**CITY OF CHARLOTTESVILLE  
BOARD OF ARCHITECTURAL REVIEW  
STAFF REPORT  
February 19, 2020**

**Certificate of Appropriateness Application**

BAR 20-02-06

North porch removal, window replacement, and new siding

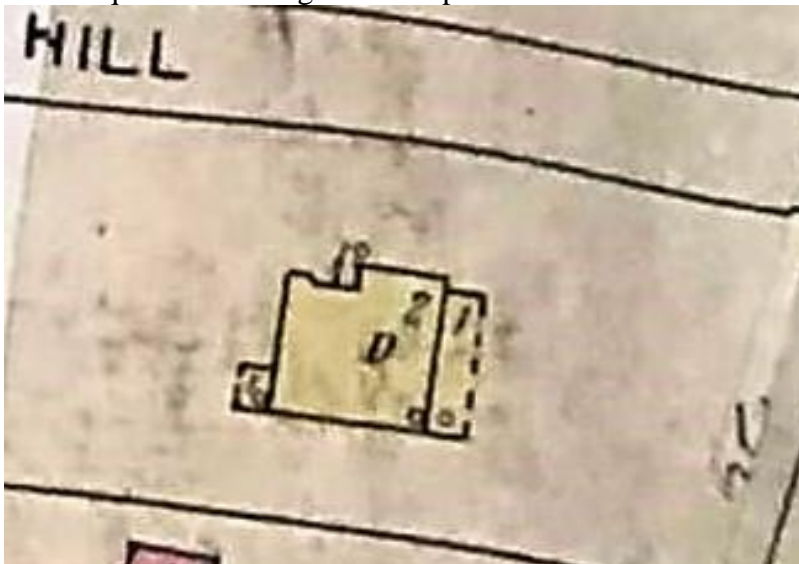
The 1929 Sanborn Map (below) indicates a single story structure at the north wall, suggesting the side entry is *at least that old*. (Earlier Sanborn Maps do not include this section of Park Street.) The house was built in 1904. (The image below is a blurry, but there is a small square visible. The “1” just above it indicates it is one-story element; the yellow indicates framed construction; the “O” indicates the type of roof.) The property is listed on the VLR and NRHP as contributing to the Charlottesville and Albemarle County Courthouse Historic District, which is taken into consideration for CoA requests involving whole or partial demolitions.
